TOLERANCES	WESTERBEKE CORPORATION AVON MA. 02322
INCHES / MILLIMETERS	TITLE: WIRING DIAGRAM/SCHEMATIC 12/24 VDC UNGND 8, 10, 11 BTD AND 12.5 BTDA
DIMENSIONS	SCALE: - / SHT. 1 of 1 / DATE: 9/3/97 / SIZE: E / DRAWING NUMBER: 42645 / REV. C

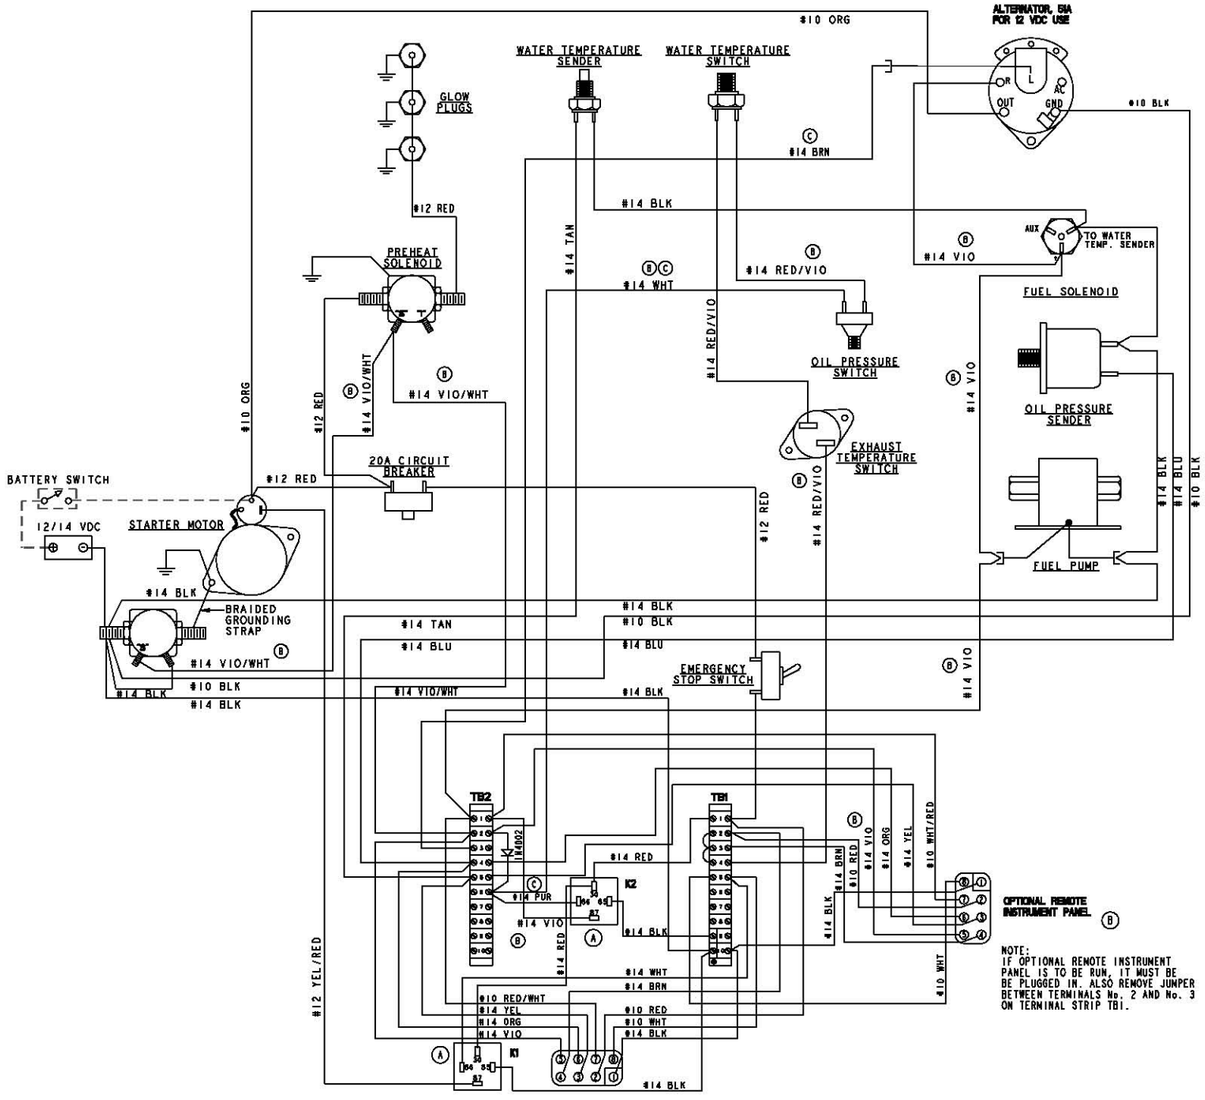
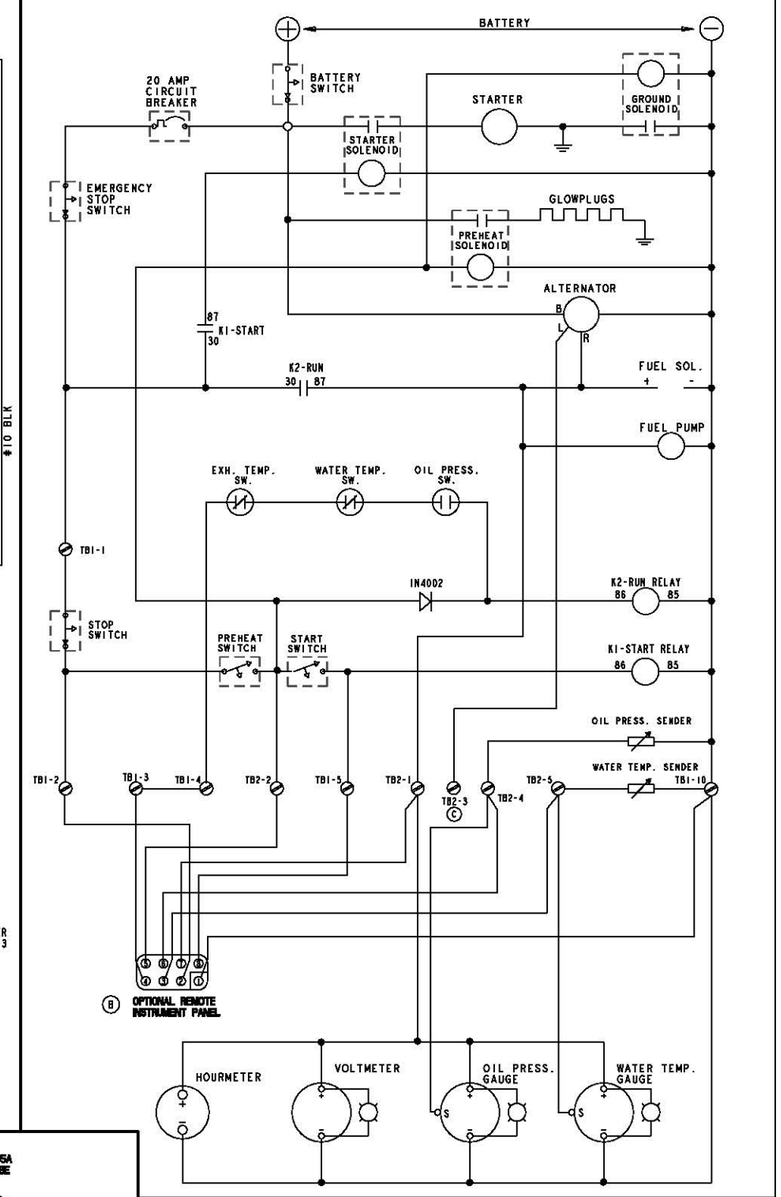
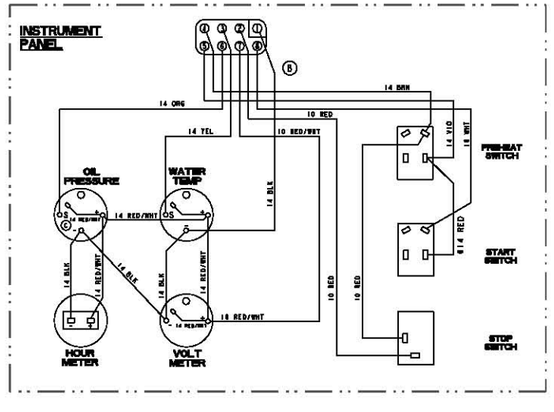
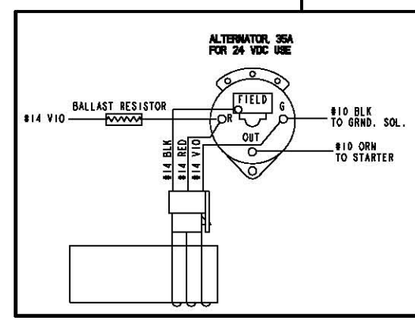
ECO NO.	DATE	REV.	REVISION RECORD	AUTH.	DR.BY
3647	3/2 98	A	ADDED (2) RELAYS TO ENERGIZE STARTER SOLENOID ADDED DIODE, REMOVED 10 AMP C.B.REDRAW SCHEMATIC.		BRN
3652	3/28 98	B	ADDED OPTIONAL REMOTE INSTRUMENT PANEL, MODIFIED WIRES TO CURRENT STANDARDS.		BRN
4206	9/9 98	C	#14 WHT WAS #14 RED/VIO, #14 PUR WAS RED/VIO ADDED WIRE (#14 BRN, TB2-3 TO ALT.)		CEU
